WIND PROJECT IN MAHARASHTRA, INDIA BY KAYATHAR AND JATH

Project Title	Wind Project in Maharashtra, India by Kayathar and Jath
Version	1.1
Report ID	VKU.VER.73.22_VCS_1520

Report Title	Wind Project in Maharashtra, India by Kayathar and Jath
Client	NSL Wind Power Company (Kayathar) Pvt. Ltd
Pages	101
Date of Issue	30-October-2023
Prepared By	VKU Certification Pvt. Ltd.
Contact	Regd. Off: Flat No. 306, Sky Star, N-1, New Rani Bagh Khandwa Road, Indore, Madhya Pradesh - 452020 URL: http://vkucertification.com e-mail: info@vkucertification.com
Approved By	Dr. Vikas Kumar Aharwal (Founder and Director) vikas.aharwal@vkucertification.com
Work Carried Out By	Barun Kumar - Team Leader cum Technical Expert TA 1.2 (Local Expert – Country: India) Niharika Kaushik - Validator/Verifier Anil Dhankar - Validator/Verifier-Trainee Komal Kumari – Project Trainee Sanjay Kumar- Technical Reviewer cum Technical Expert TA 1.2

Figure 2.1: Trends of PLF from May 2022 to December 2022 (Current MP)

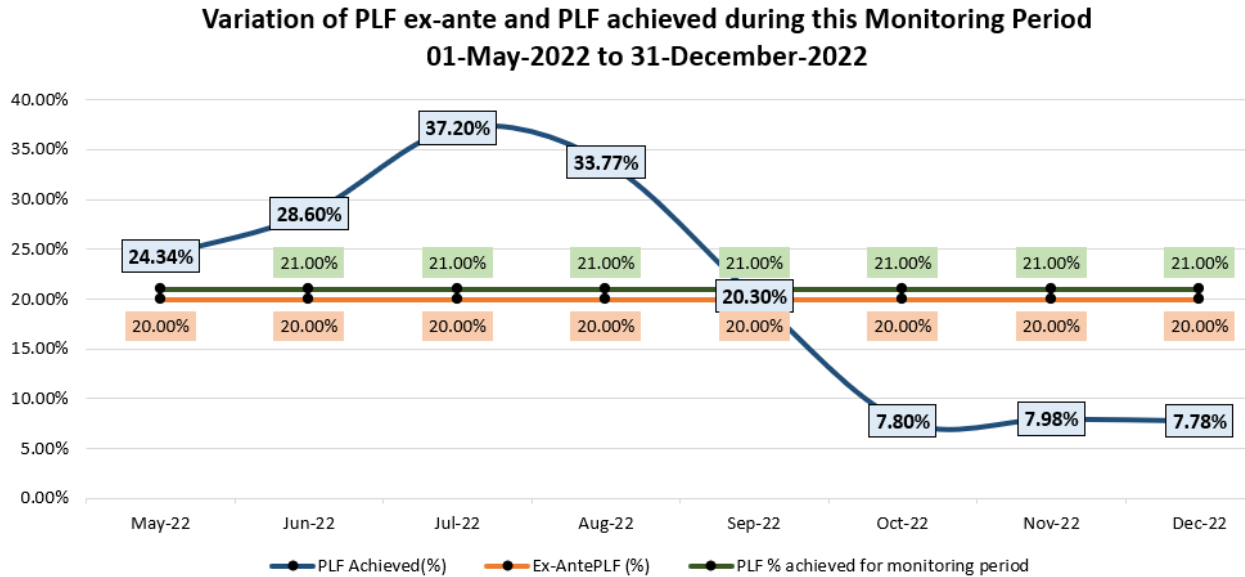
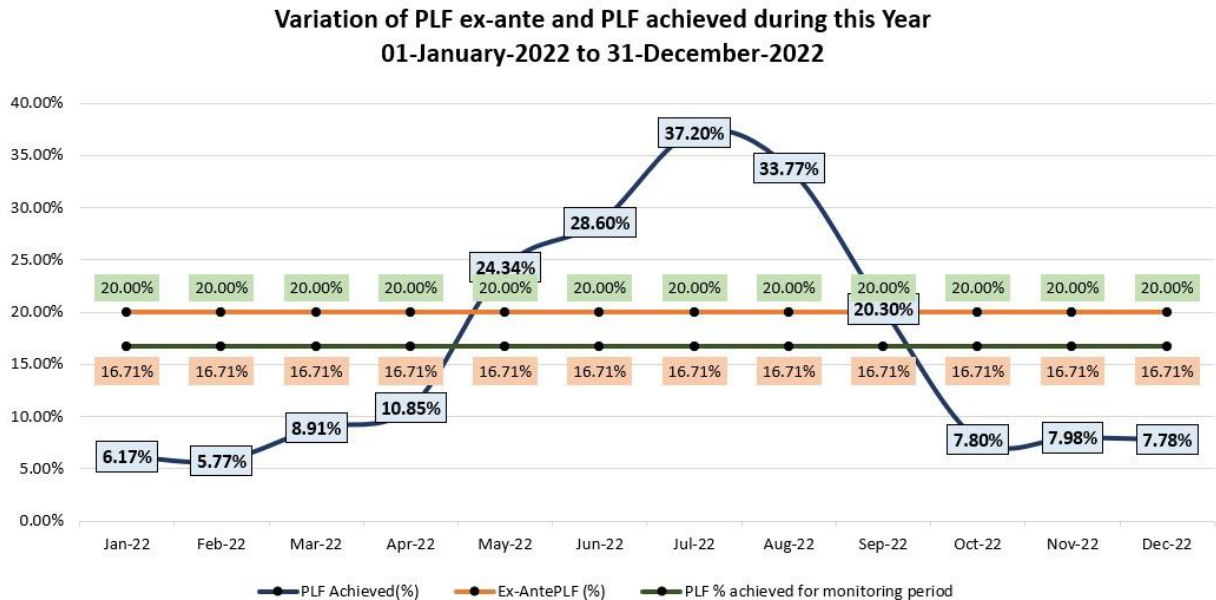
Based upon the Figure 2.1 & 2.2, it is clear that the trend of PLF before April 2022 is lower than estimated from May-2022 till September-2022 the PLF is higher than the estimated and also after September-2022 the trend of PLF is lower than the estimated. Which is due to seasonal availability & variation in wind flow which is directly reflected in higher emission reductions for the current monitoring period at +4.98%.

The higher generation during the current verification period is hence due high wind flow, grid availability, high PLF & minor scheduled & unscheduled breakdown as verified and traced through evidences and calculative computation by VKU assessment team during desk review, onsite visit and interview with site personnel confirmed the reasons of higher emissions reduction as compared with registered VCS Joint PD & MR Version 02 dated 19-March-2016/3/ & hence acceptable to VKU.
